SUMMARY OF CHANGES:

PROJECT
URBN SURF SYDNEY
HILL ROAD, SYDNEY OLYMPIC PARK NSW

STATUS \$4.55 DEVELOPMENT APPLICATION	DRAWING LEGEND AND MATERIALS SCHEDULE
DRAWING SCALE	NORTH POINT
PROJECT No S19-023	SHEET SIZE A1
DRAWING No L001	ISSUE D

DRAWING
SECTIONS & ELEVATIONS
SECTION LOCATION PLAN

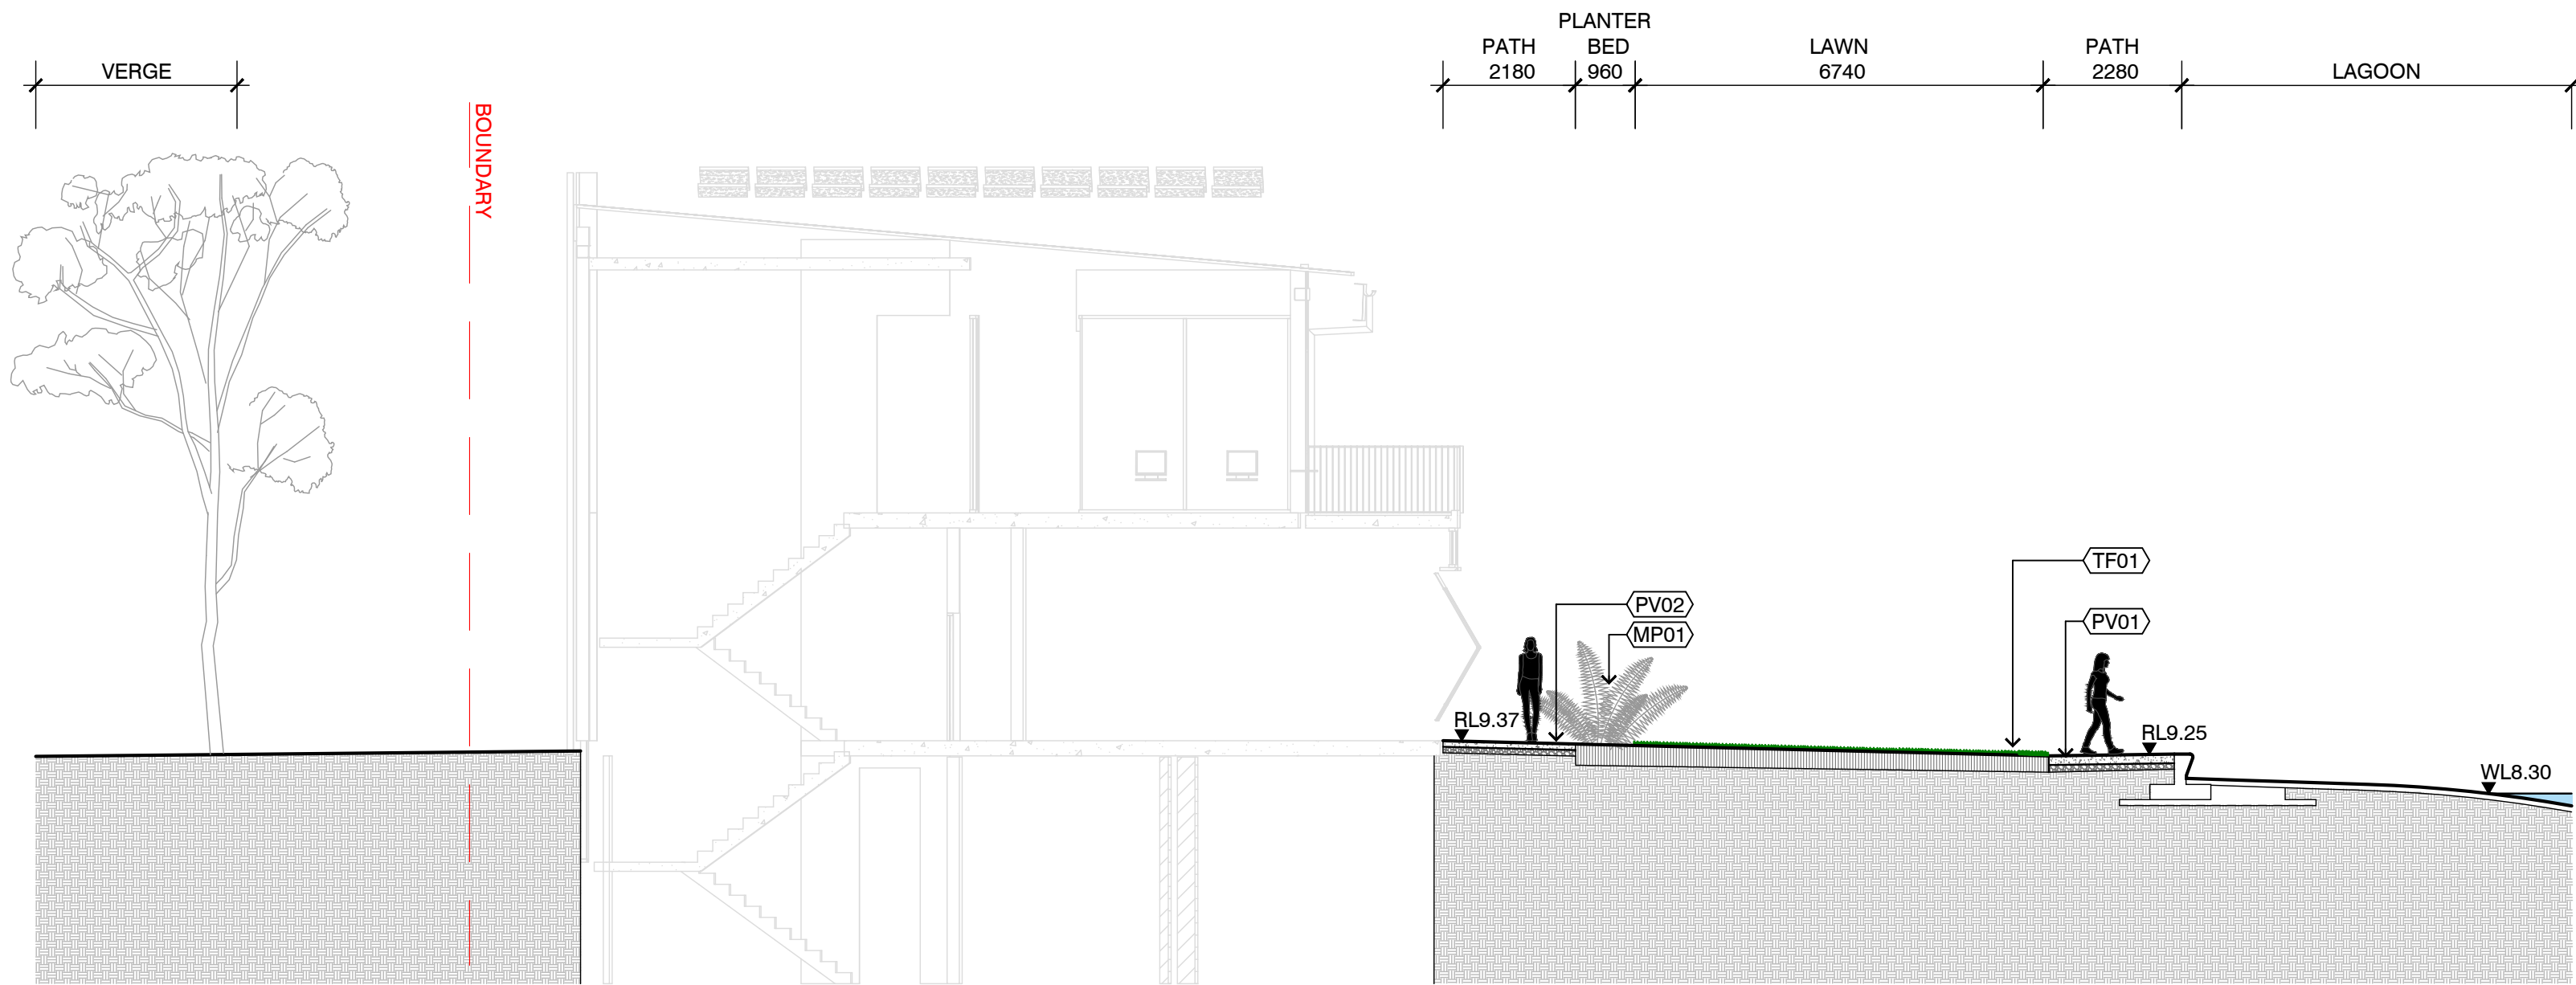
A. ADDITIONAL SECTIONS TO EVENTS HILL

DRAWING
SECTIONS AND ELEVATIONS

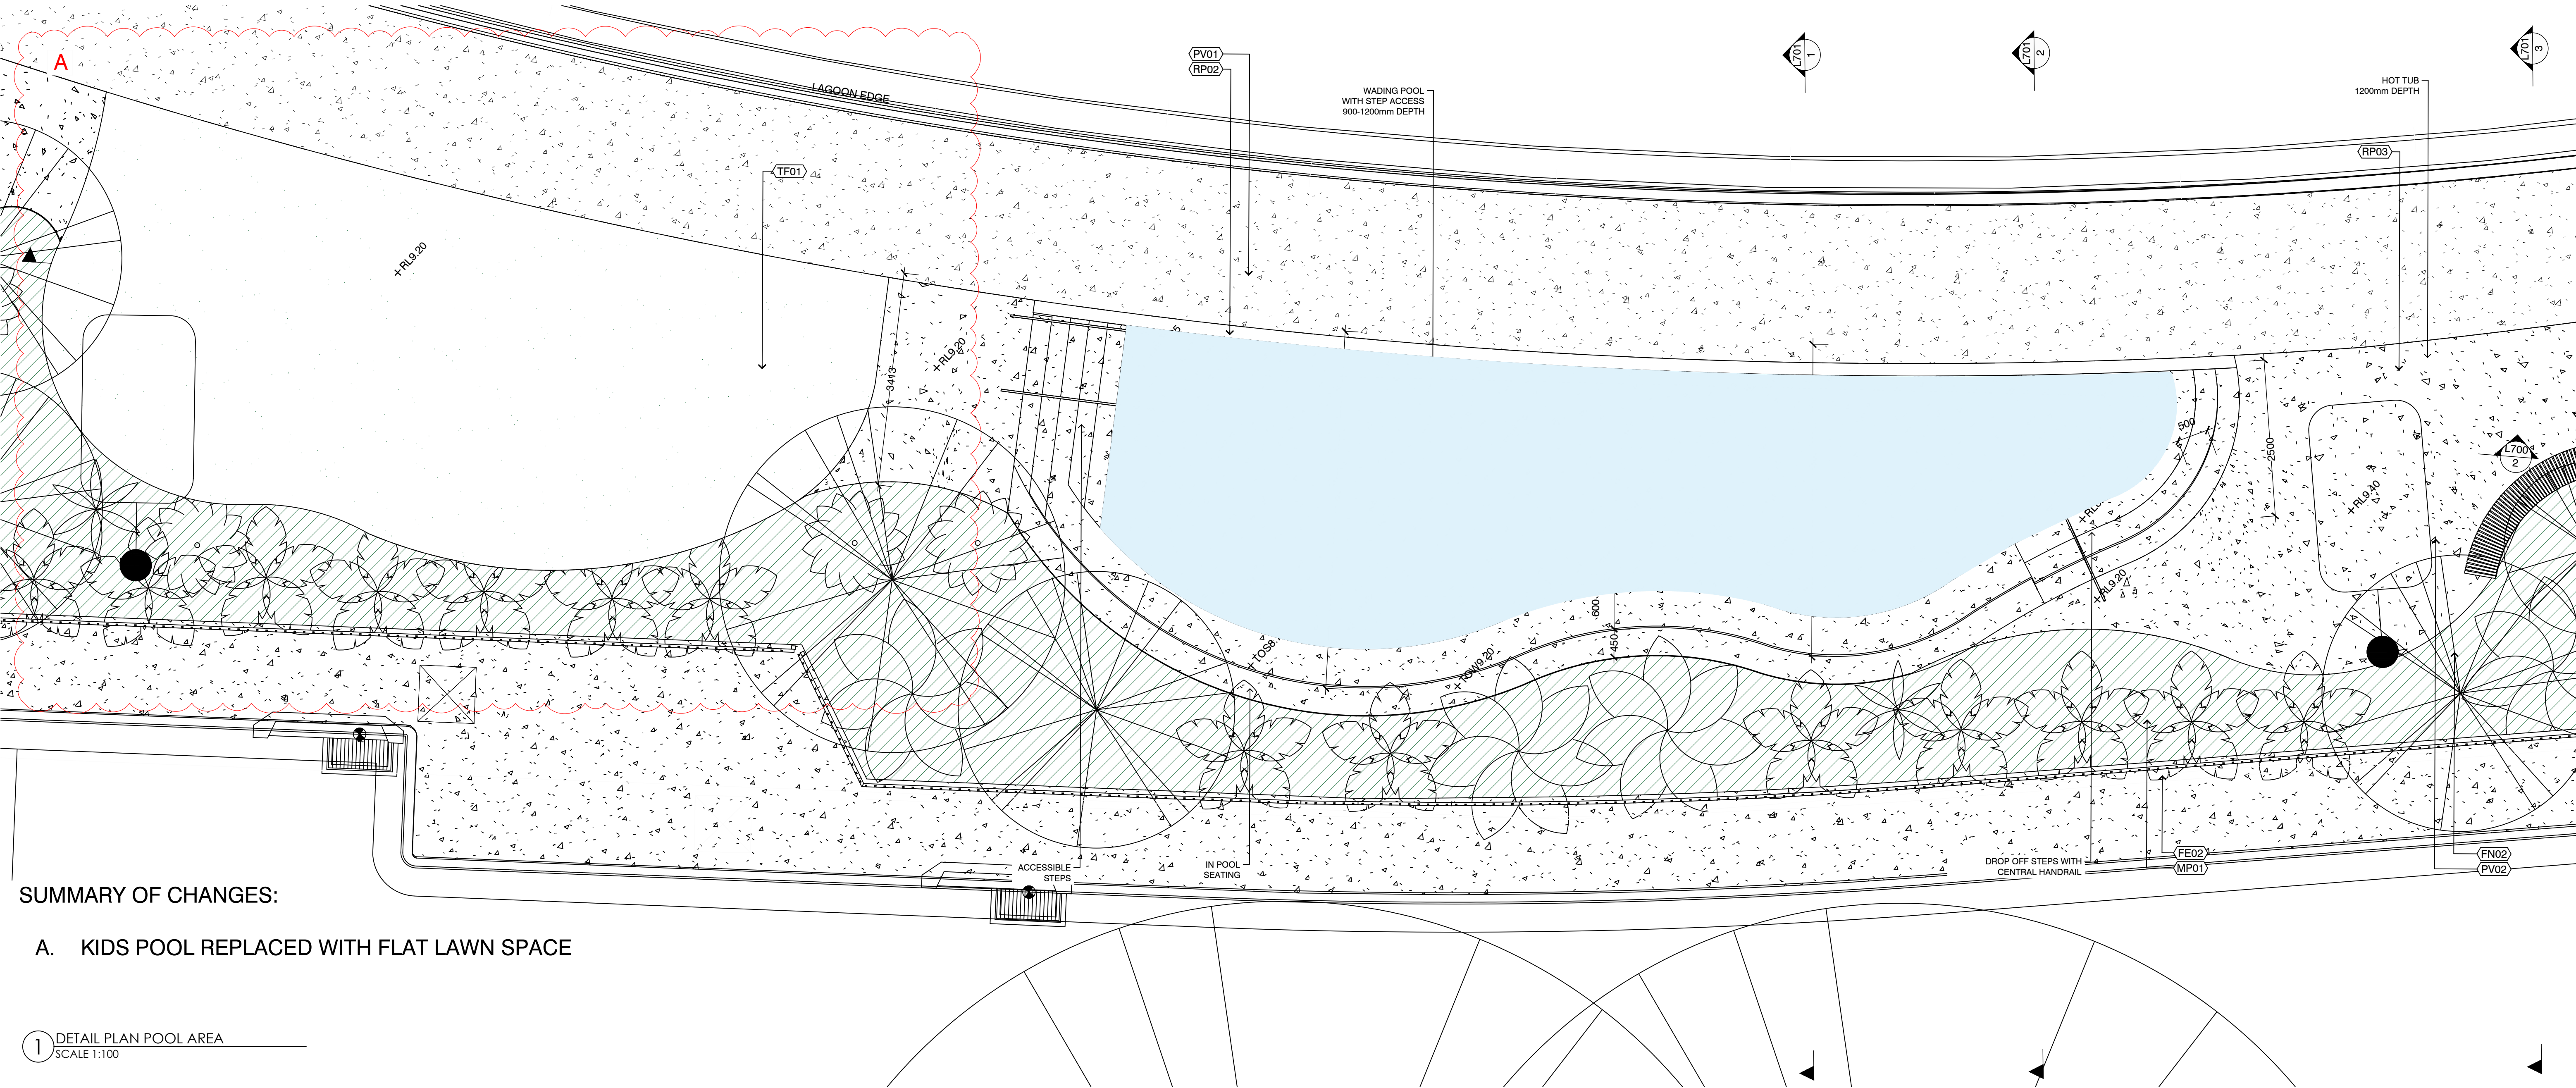
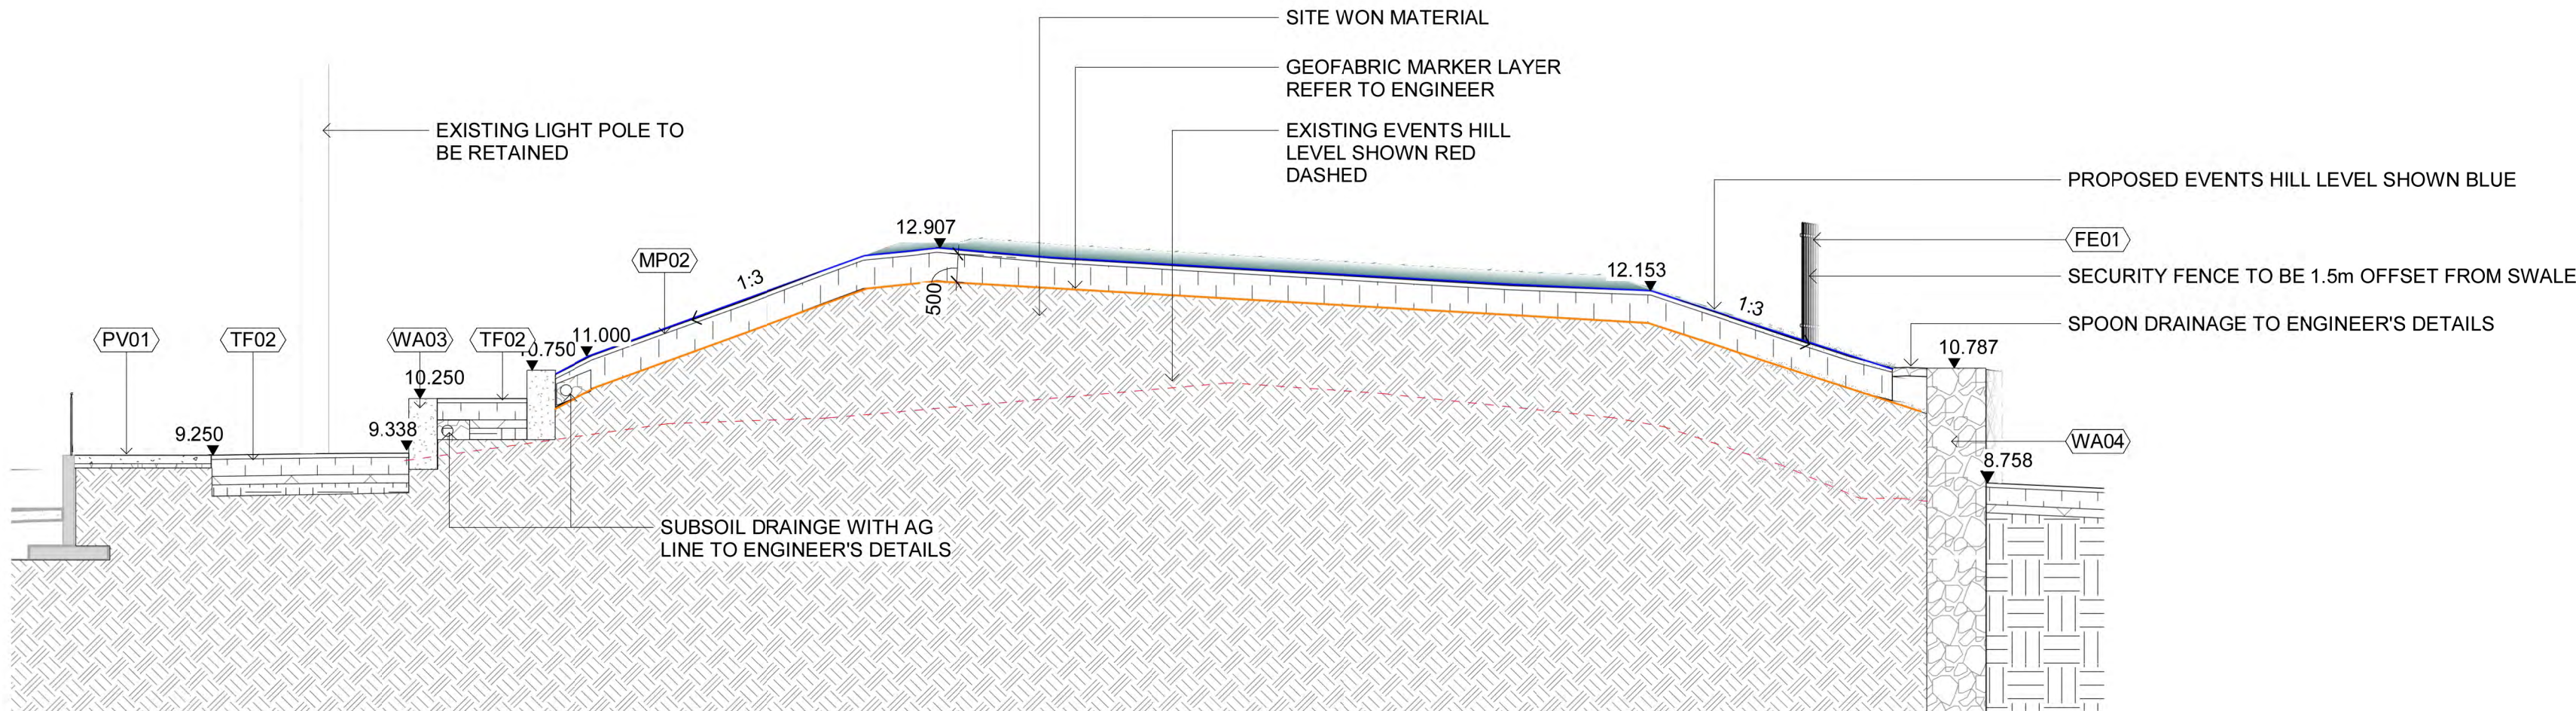
A. EVENTS HILL DESIGN UPDATED WITH SANDSTONE BLOCK SEATING WALL TO BASE OF HILL ALONG WITH SANDSTONE STAIRS. EVENTS HILL RE-GRADED TO GENERALLY 1:3 REFER TO CIVIL ENGINEER'S DOCUMENTATION

DRAWING POOL DETAILS

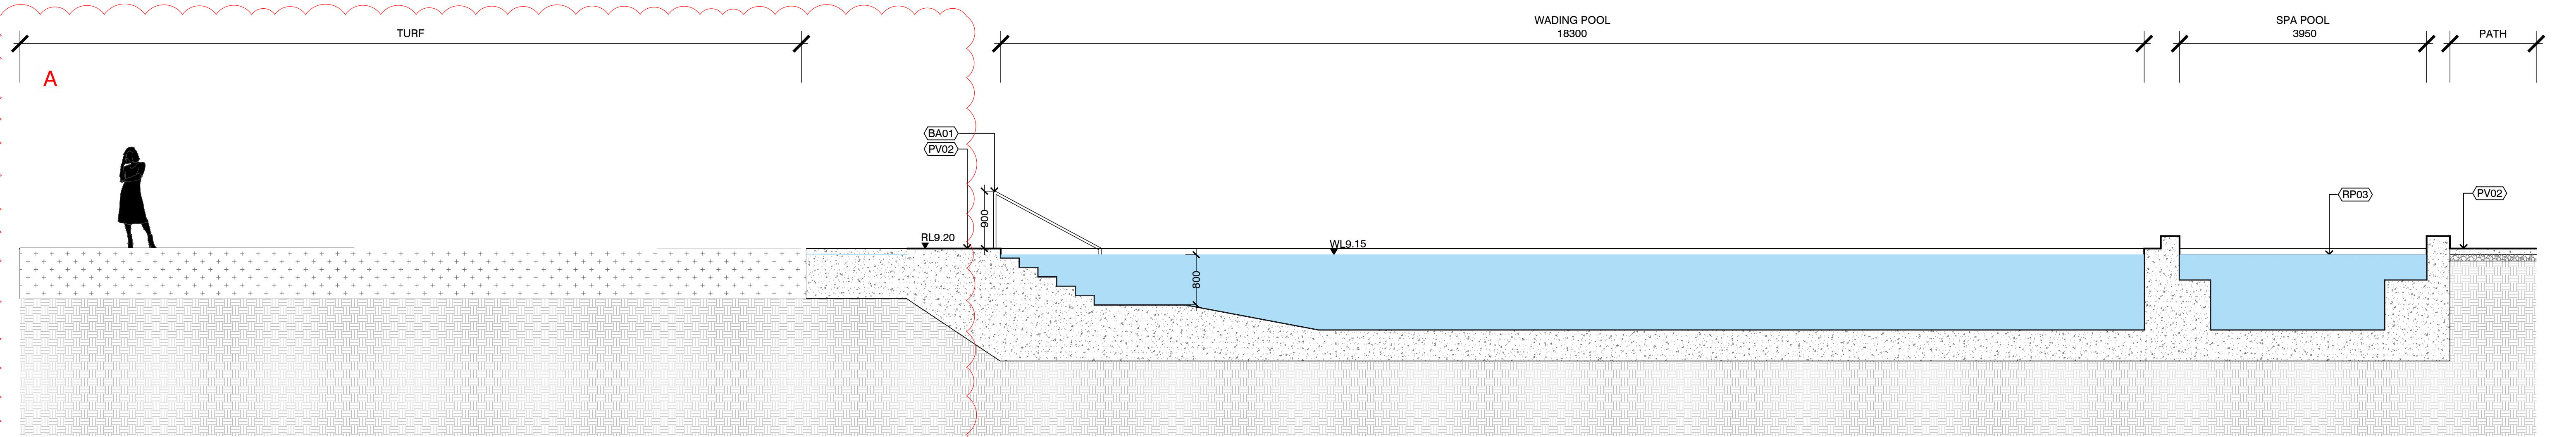
A. KIDS POOL REPLACED WITH FLAT LAWN SPACE
